TAHMOOR COAL MINE LONGWALLS W3-W4 EXTRACTION PLAN

Reasons for Approval

Figure 1: Proposed longwall layout

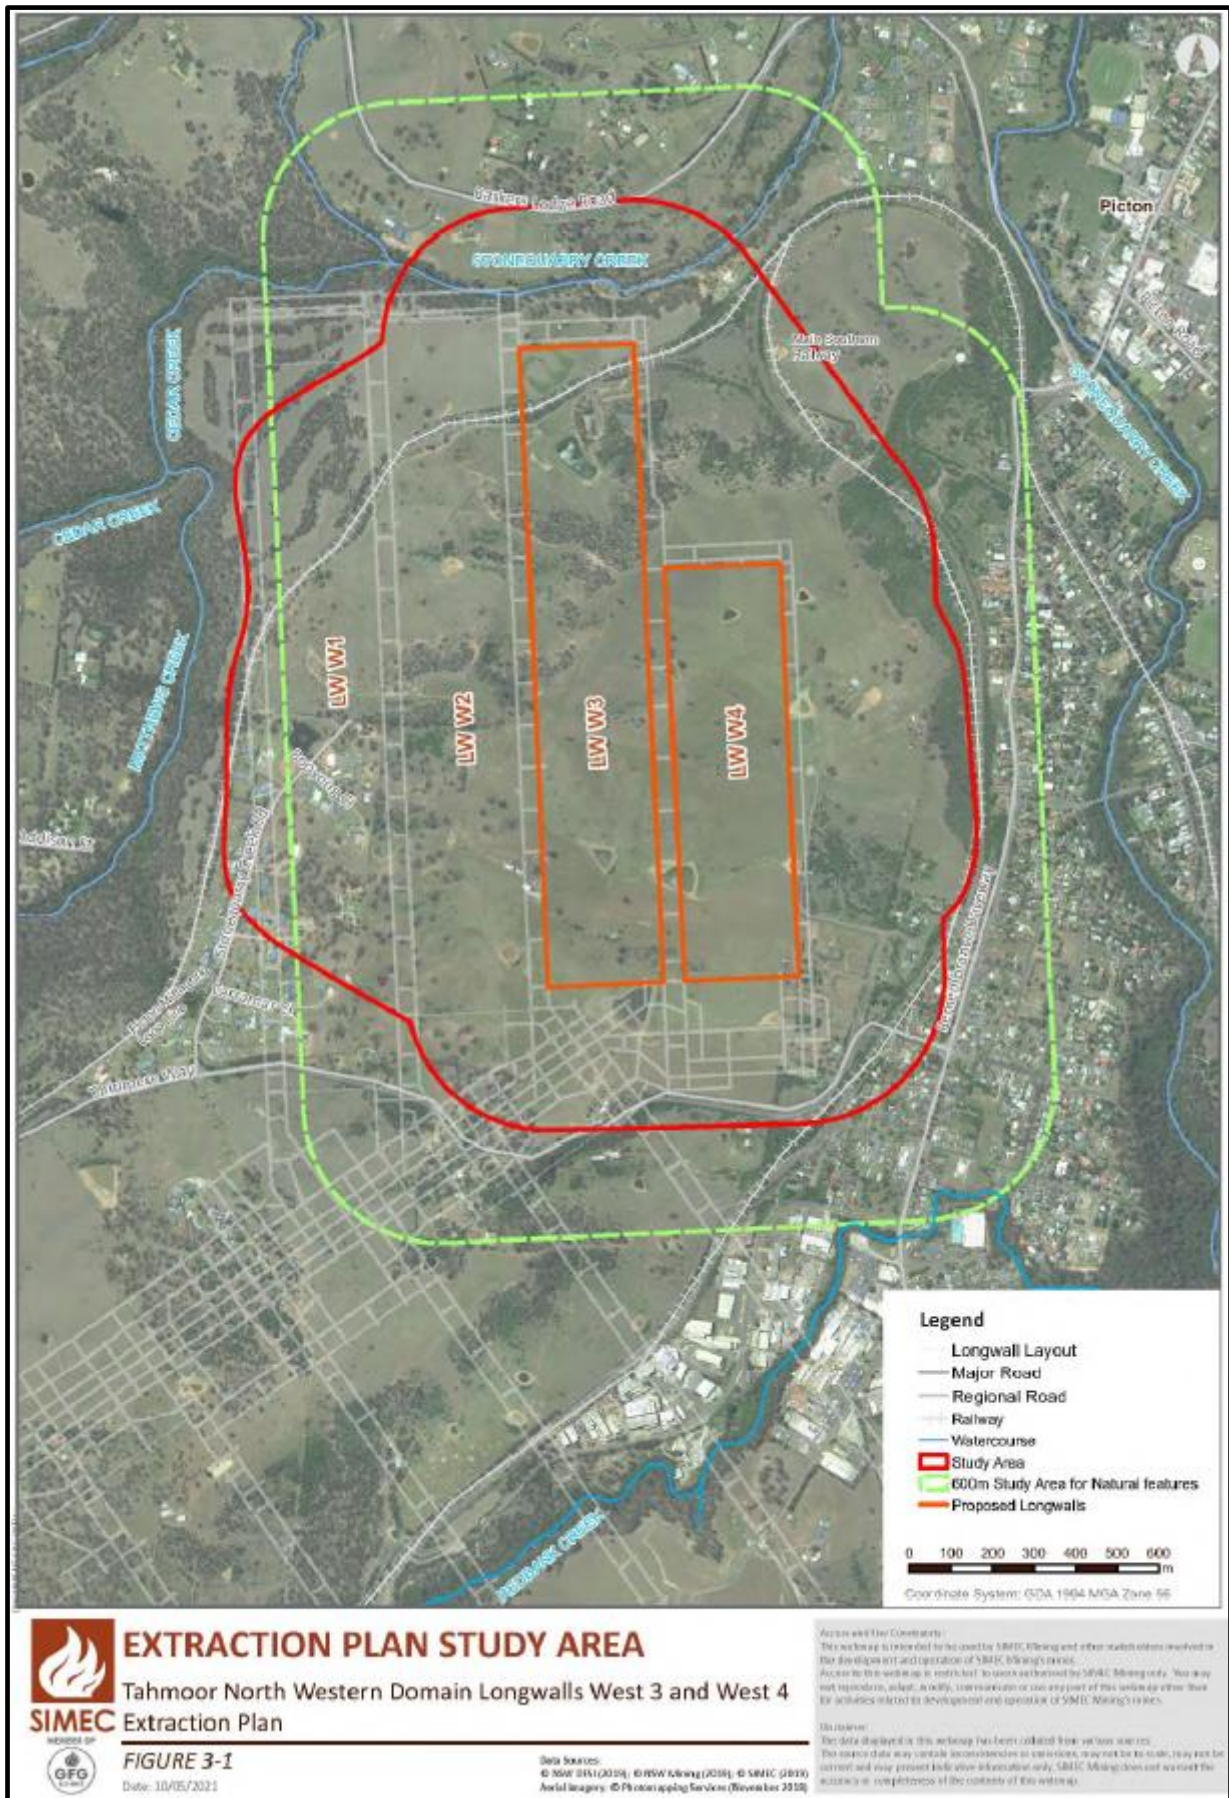
- The Western Domain mine plan comprises a series of four longwall panels, longwalls W1 to W4 (refer to **Figure 1**), and are the final panels to be mined under the Tahmoor North development consents.

- While the revised layout avoids directly undermining several high-order creeks, including Cedar (5th order), Stonequarry (5th order) and Matthews Creeks (4th order), the northern end of longwall W3 is still in close proximity to Stonequarry Creek and some surface impacts are still expected.

- A large and culturally significant controlling rockbar (SR17) is located on Stonequarry Creek approximately 100 metres from the northern commencing end of longwall W3. The rockbar contains approximately 120 grinding grooves that are considered highly culturally significant and rare in the region. Rockbar SR17 retains a large permanent pool approximately 670 metres in length.

- On 10 May 2021, the Department received an Extraction Plan for longwalls W3 and W4 in the Western Domain mining area of the Tahmoor Coal Mine (refer to **Figure 1**).
